SUBJECT: ISSUANCE OF EMERGENCY AMENDMENT FOR THE PALO VERDE NUCLEAR
GENERATING STATION UNIT NO. 2 (TAC NO. M90581)

Amendment No. 71

SAFETY EVALUATION BY THE OFFICE OF NUCLEAR REACTOR REGULATION
RELATED TO AMENDMENT NO. 71 TO FACILITY OPERATING LICENSE NO. NPF-51,
ARIZONA PUBLIC SERVICE COMPANY, ET AL.
PALO VERDE NUCLEAR GENERATING STATION, UNIT NO. 2

Battery Capacity Comparison

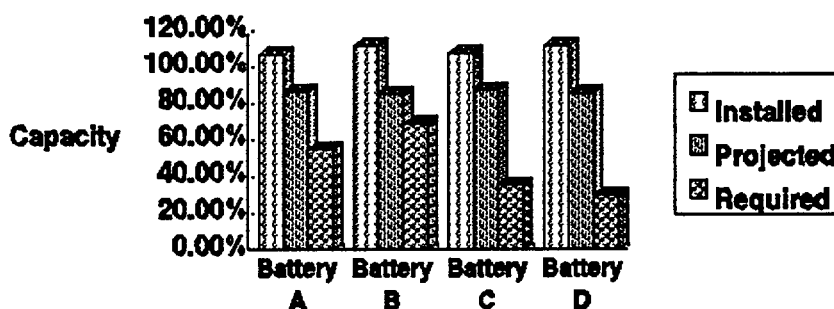
Although battery capacity is less than required by Specification 4.8.2.1.e, sufficient capacity remains for the batteries to perform their intended function. The following graph demonstrates the margin in capacity based on projected capacity after the replacement of 31 cells as described above.

In the most limiting case, the B battery still has greater than 15% margin between the projected and required capacities. Therefore, the proposed change to battery capacity requirements does not involve a significant reduction in a margin of safety.

The NRC staff notes that by letter dated October 12, 1994, the licensee stated that the electrical load calculation for bank B battery has been completed, thereby ensuring that the bank A load profile is the worst-case profile. This recalculation provides additional margin between the worst-case projected and required capacities (Battery A has greater than 25% margin). The NRC staff agrees that the above standards are satisfied and, therefore, determines that the amendment request involves no significant hazards consideration.
